Project No. 12091-01

**Subject: Preliminary Geotechnical Evaluation and Response to City Review Comments for Proposed San Pedro Distribution Center, 1599 W. John S. Gibson Boulevard, Los Angeles, California**

## **5.0 RESPONSE TO CITY REVIEW COMMENTS**

PROJECT NAME	San Pedro Distribution Center
PROJECT NO.	12091-01
ENG. / GEOL.	BTZ / KBC
SCALE	1" = 40'
DATE	March 2019

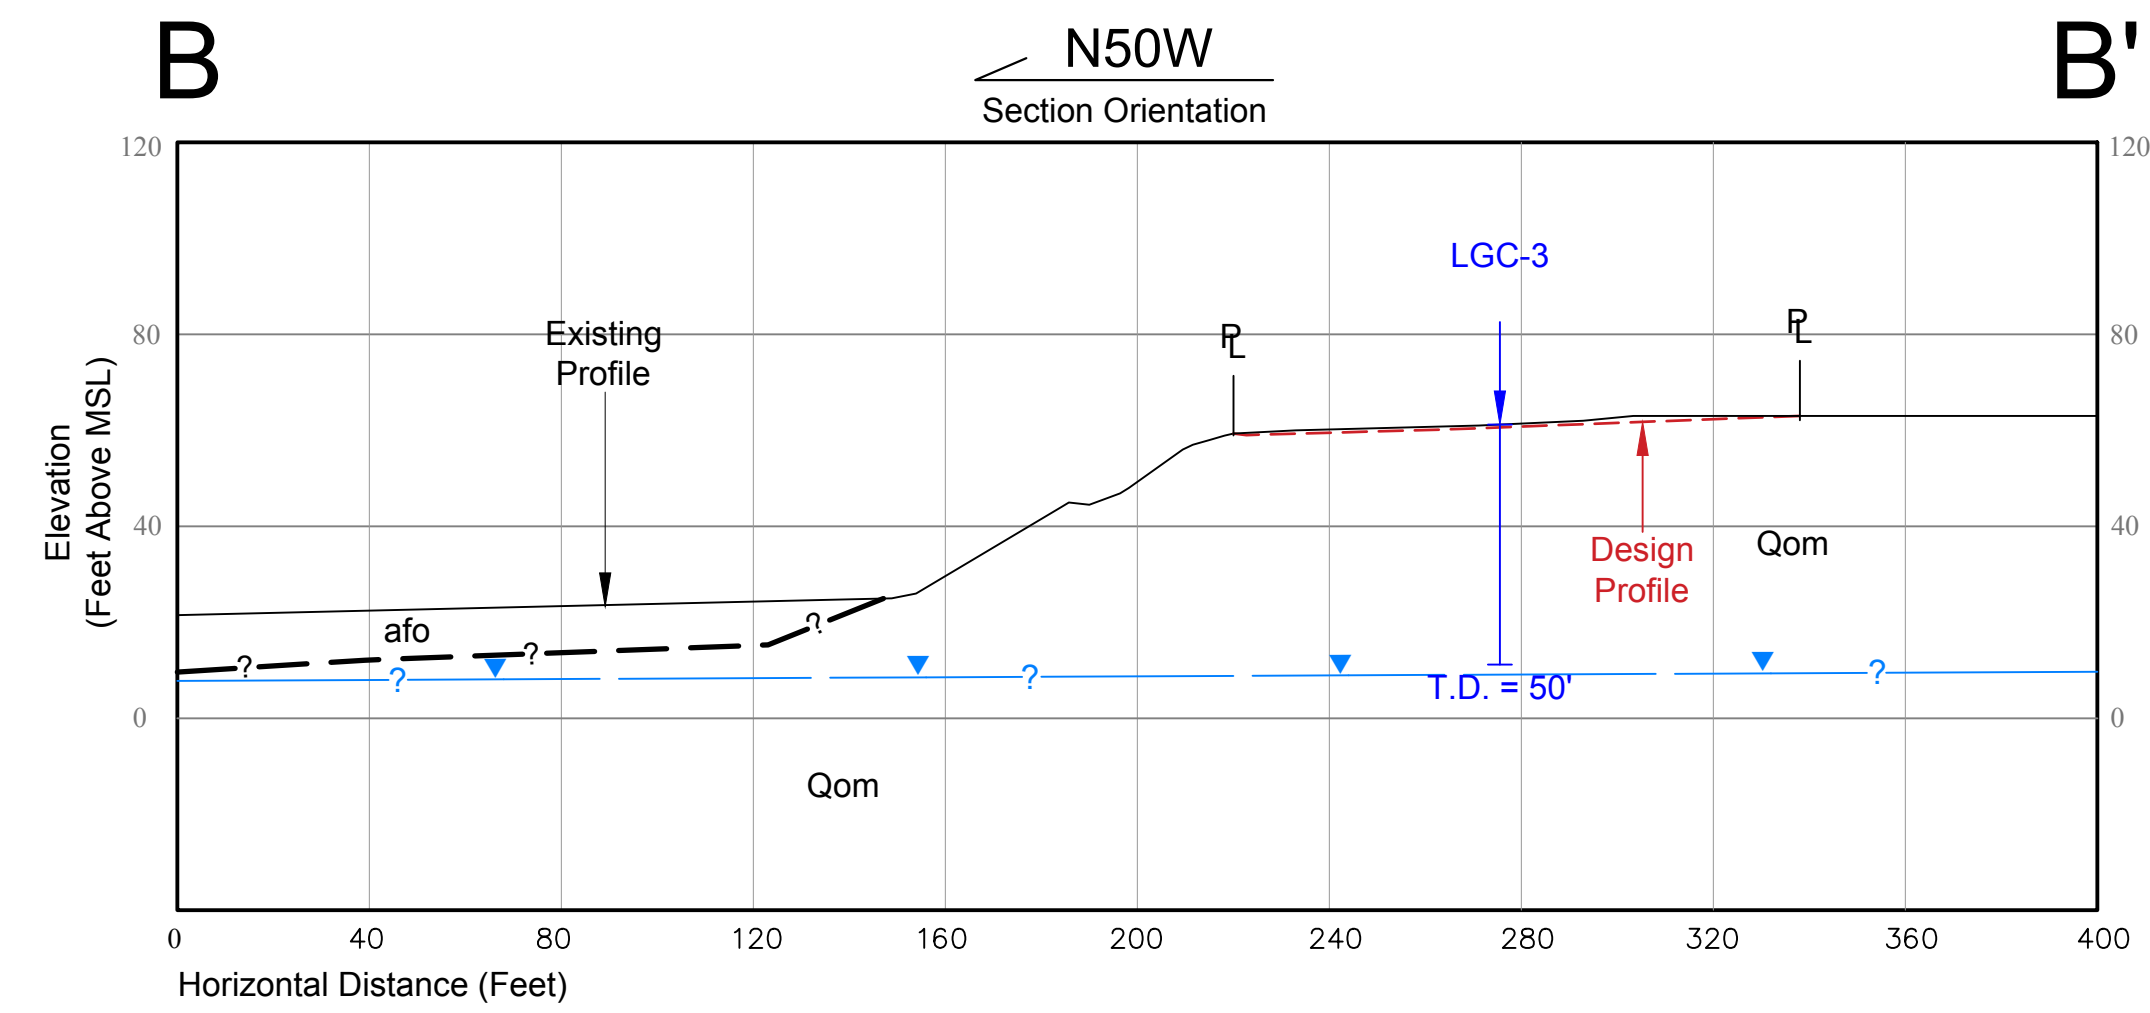
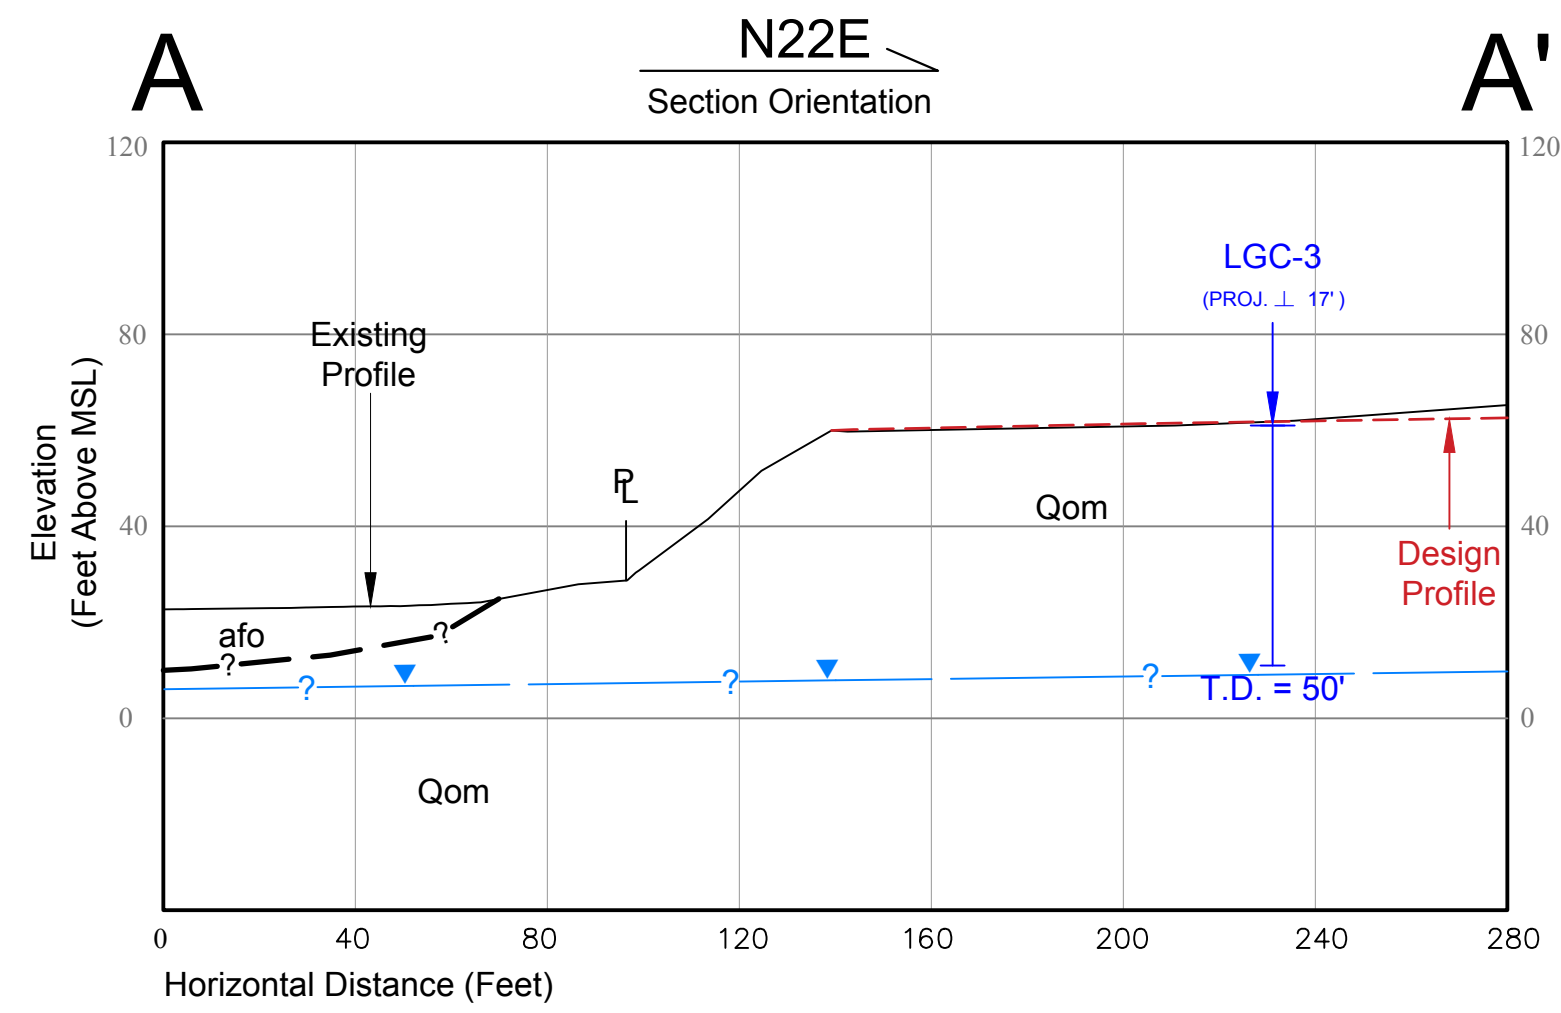
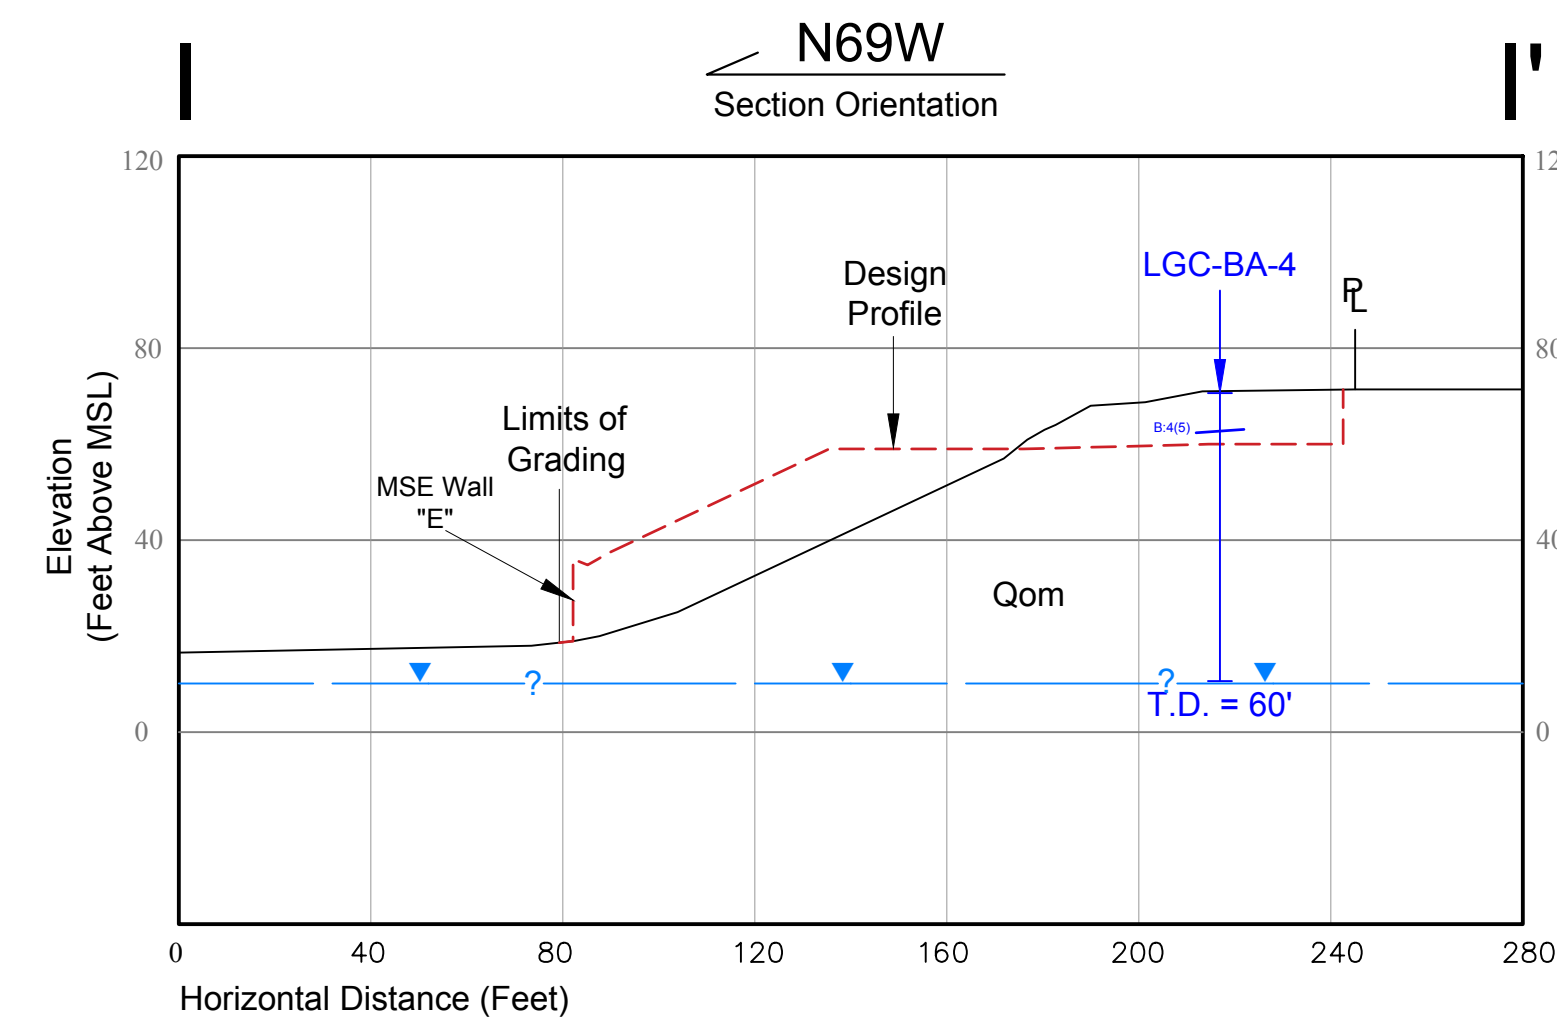
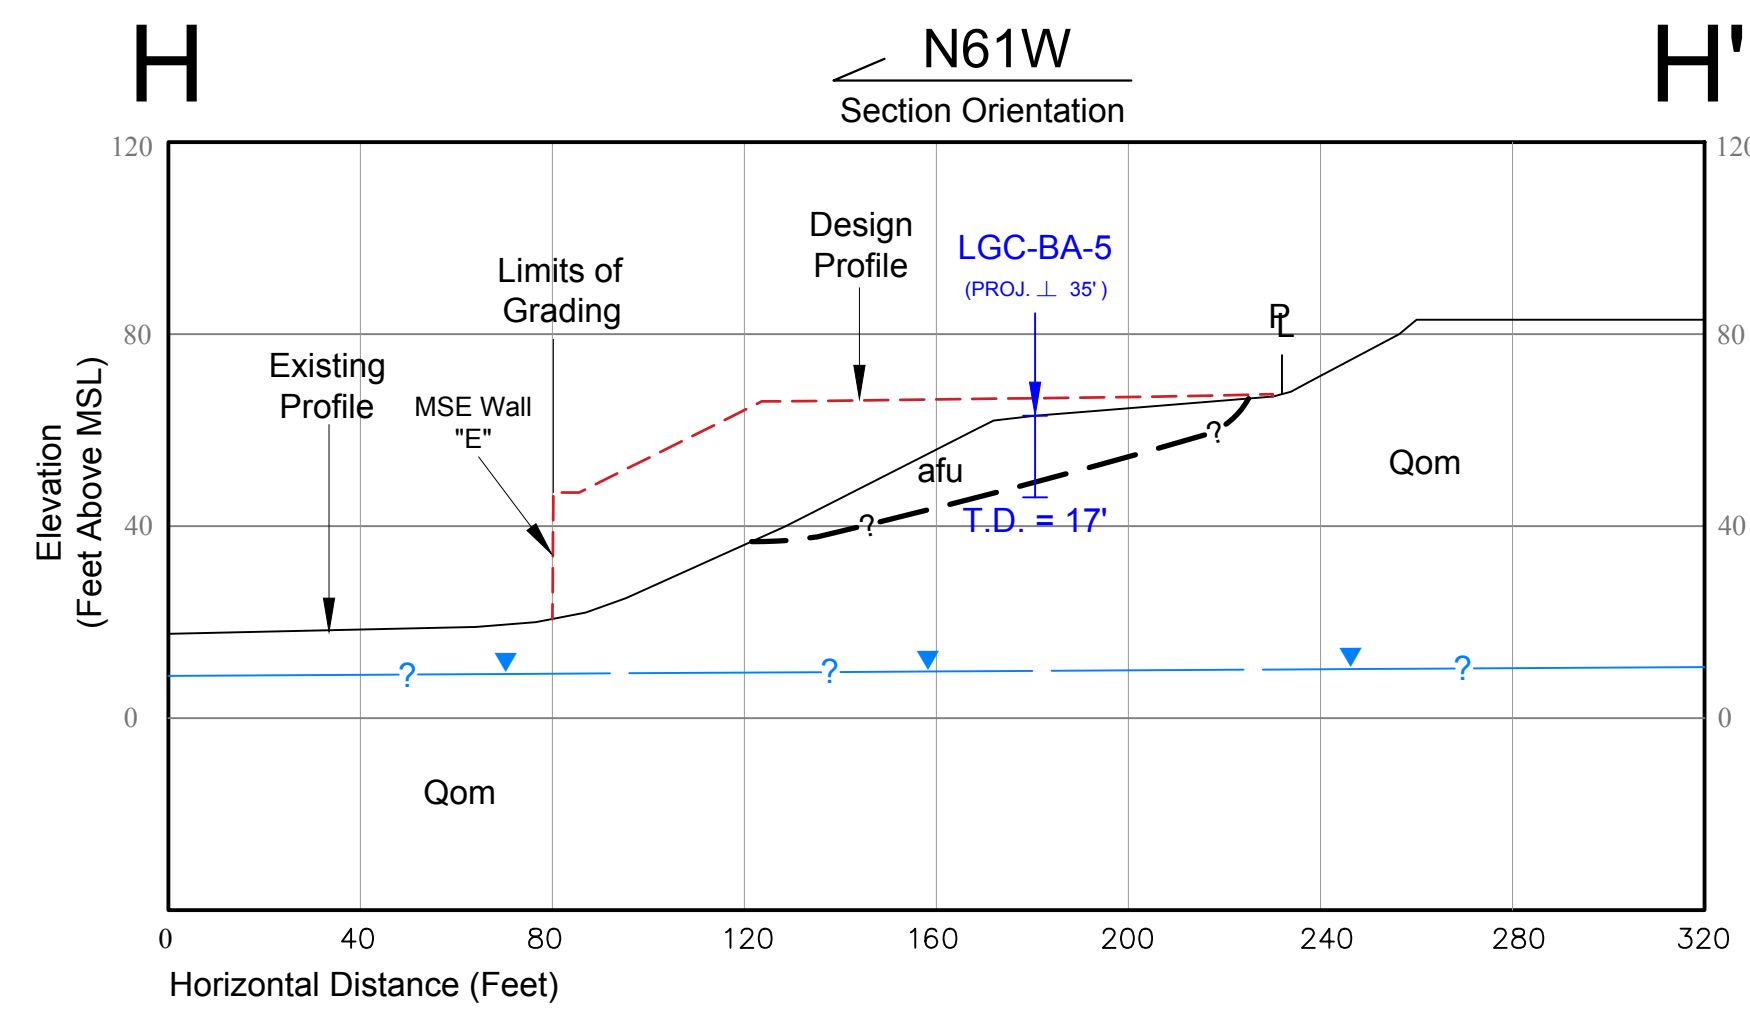
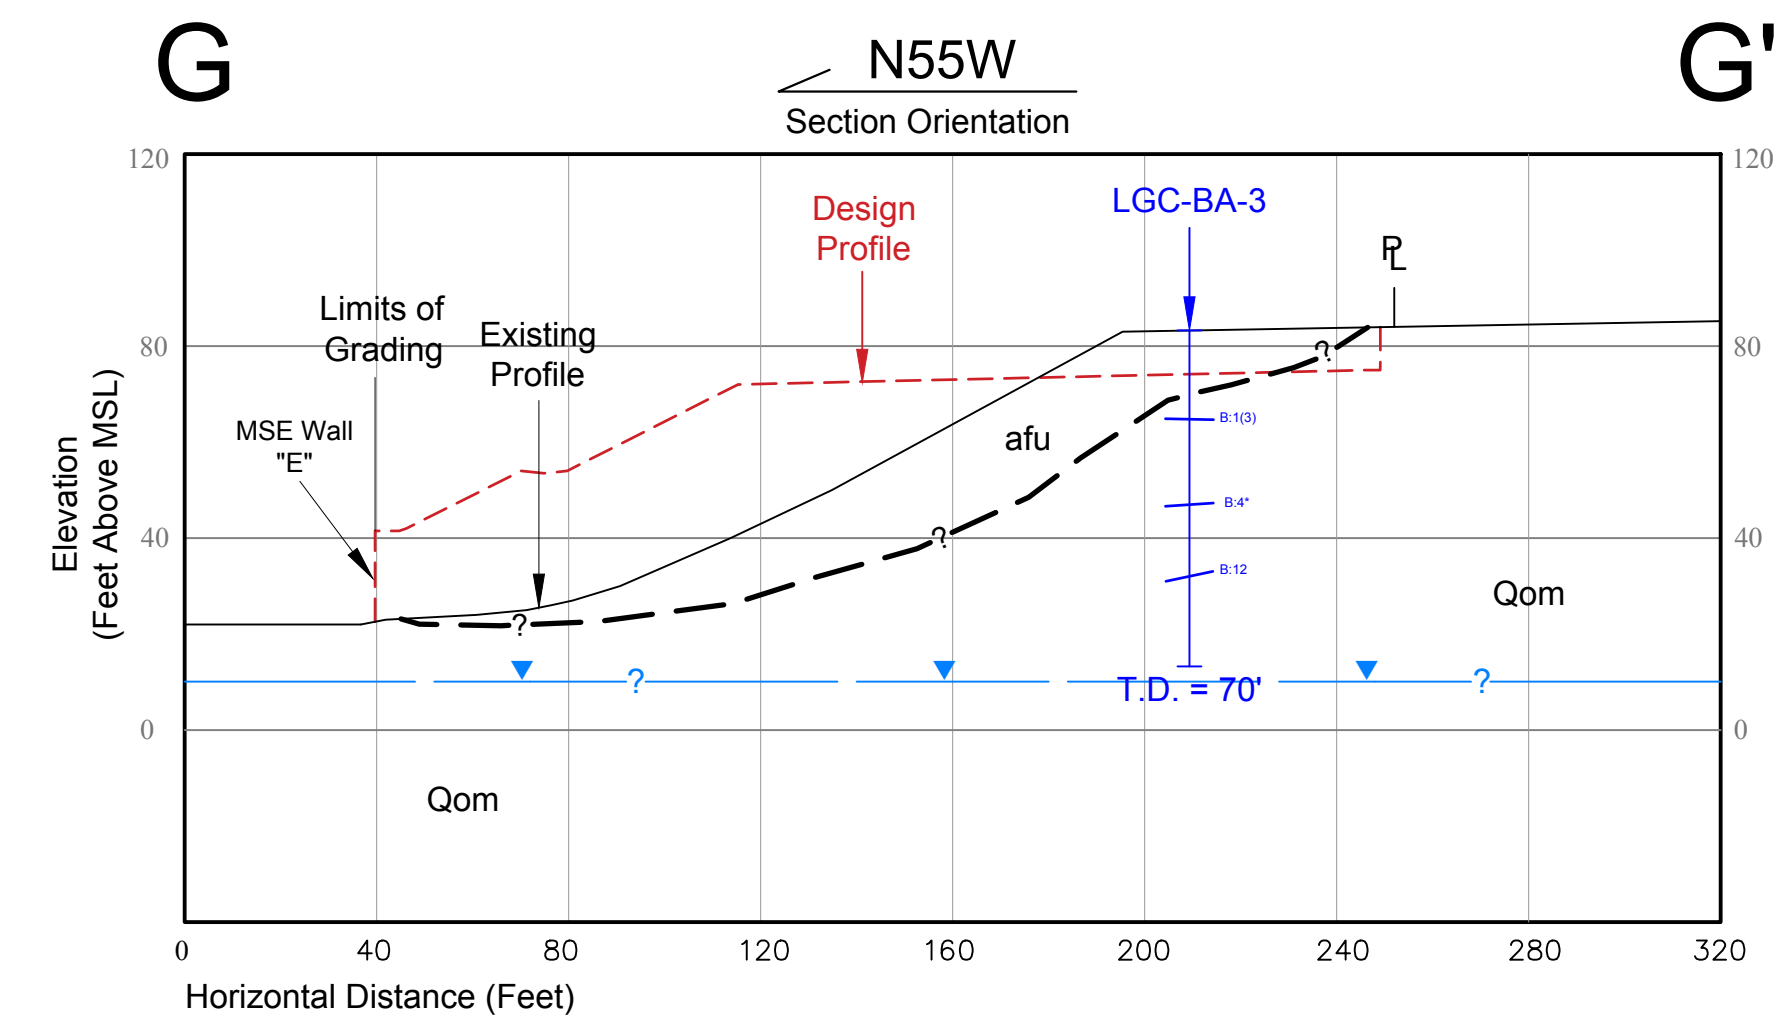
“Provide a geologic map and cross sections that are based upon conceptual grading or site development plans, to illustrate all proposed and existing contours relative to the planned grading and/or construction, along with all off-site slopes and conditions that could adversely affect the stability or safety of the site (7006.3.2). The geologic map and cross sections shall depict the top and bottom of slopes; lithologic contacts; bedding attitudes; locations of slumps, landslides, or faults relative to the subject site; existing and proposed topographic profiles; existing and proposed structures; and, required Code setbacks. (7006.3.2)”

Refer to the attached Geotechnical Map and Geotechnical Cross Sections (Sheets 1 through 5). No building structures are planned for the site.
